PLANNING, ZONING, & BUILDING DEPARTMENT
PZ&B Staff Combination Memorandum: Town Council and Architectural Commission

SUBJECT: ZON-24-0050 (ARC-24-0036) 333 SUNSET AVE (COMBO)

MEETING: NOVEMBER 13, 2024, TC
NOVEMBER 22, 2024, ARCOM

Floor plan of existing penthouse level

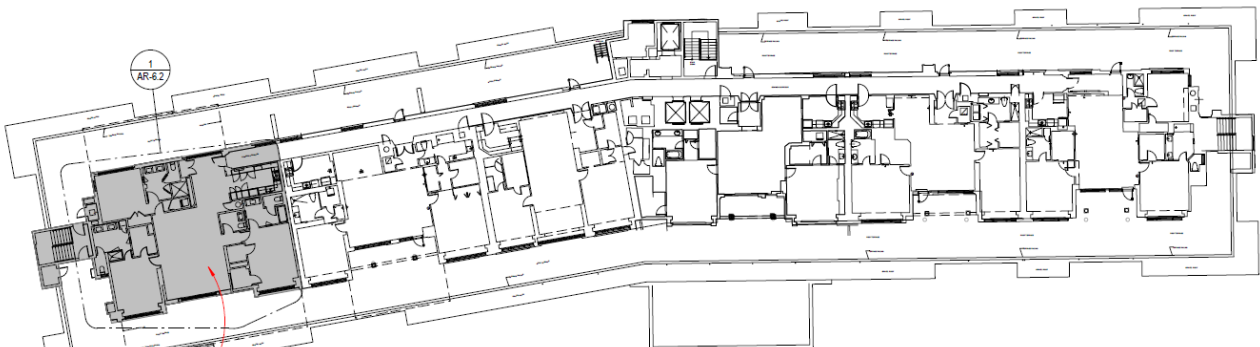
As previously mentioned, all six (6) penthouse apartment units on the rooftop (7th) level have private outdoor terraces with previously installed tensile, fabric shade canopies. These fabric awnings were/are visible from the right-of-way.

Each penthouse unit has expansive north and south private terraces. Prior to the 2022 renovation, each one had vinyl shade elements that were permitted and re-permitted over the years from the 1980s, 1990s, and 2000s. It is worth noting that none of these elements were reviewed by the Architectural Commission.

Site plan (blue depicts rooftop locations of aluminum shade structures)

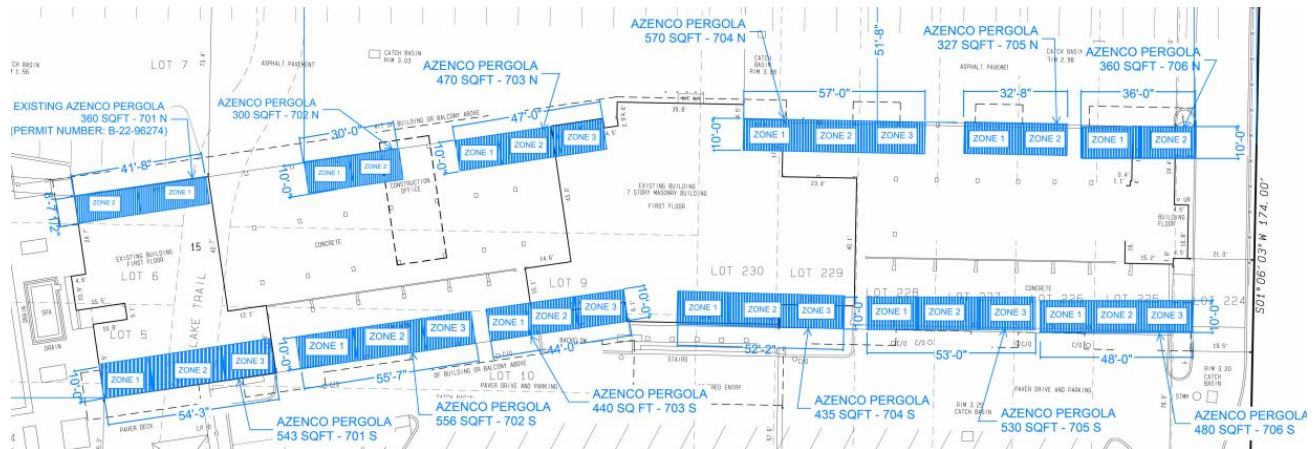
Each of the new proposed aluminum shade structures will match the footprint of the replaced canopy elements and measure a maximum of 9'-7 1/4" high, the precise areas range in size from 360 SF to 556 SF. Note that one of these elements is already installed on the rooftop, at the western edge of the penthouse level, approved under building permit B-22-96274 as part of the prior combo project. B-22-96274 was for "ACCESSORY STRUCTURE: INSTALLATION OF OPEN TRELLIS". It was applied for on 08/31/2022, issued on 12/21/22, and final on 04/13/23.

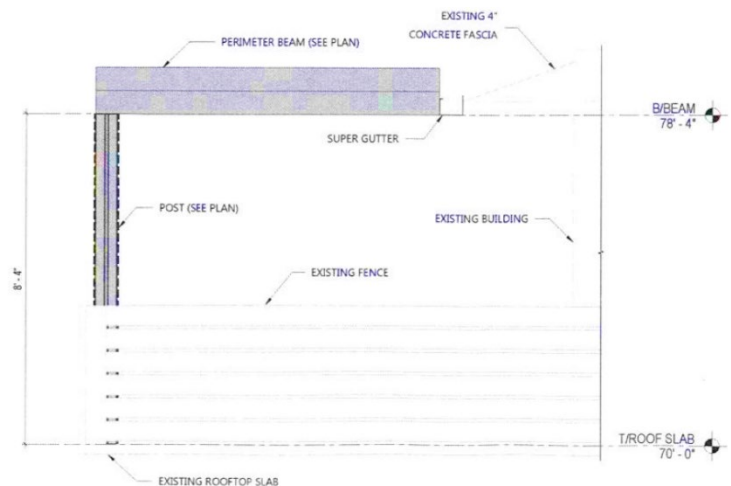
The current aluminum shade structures are proposed to be powder-coated white to blend with the architecture of the building. Two 8" wide vertical posts are proposed to be installed on top of the existing guardrail.

As it pertains to the variance to exceed maximum building height of 62.5' (and overall height of 67.5') for the installation of the rooftop structures, the existing building is nonconforming in regards to its height in the R-D (2) district, therefore any introduction of new rooftop elements—trellises, outdoor kitchens, shade structures or even planters—would require a variance.
